Burk Plaza

6. **DR97-82** - Approval of signage package for Burk Plaza, Phases I and II, located at the SEC of Burk Street and Baseline Road.

SIGN AREA 39
SCALE 1/2" = 1'0"

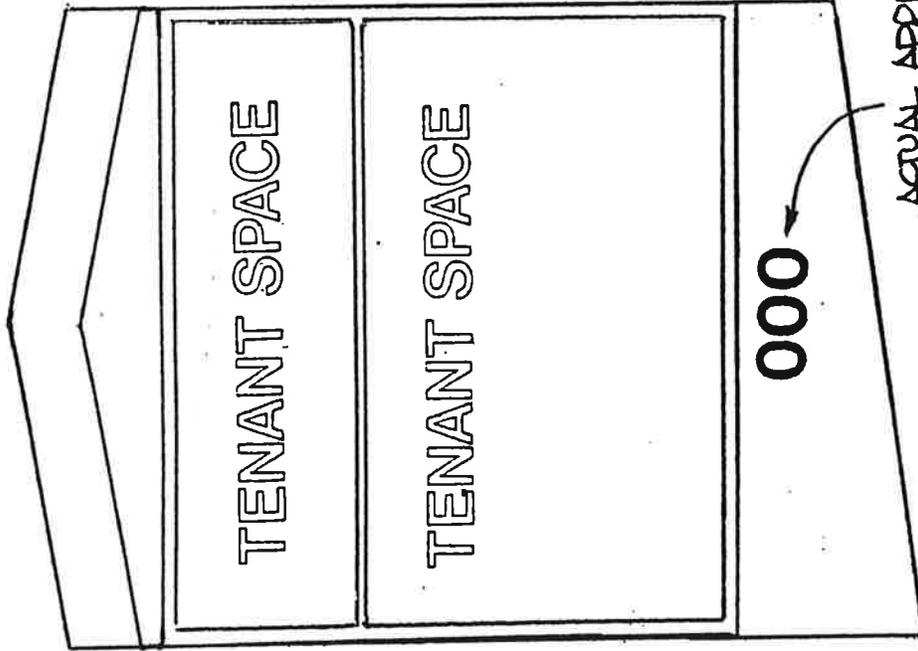
3. Freestanding signage adjacent to Burk Street shall provide center identification 'Burk Plaza', at the top one-third (1/3) of the sign.

4. Each freestanding sign shall not exceed sixty-three (63) square feet in area, nor eight (8') feet in height. Said height of signs shall be measured from the top of curb of the parking lot. Calculations for area shall not include architectural embellishment proposed at apex of sign.

5. The freestanding monument sign adjacent to Burk Street shall be repositioned approximately eighty (80') feet to the south to provide an approximate separation from the existing AM/PM sign of one hundred fifty (150') feet.
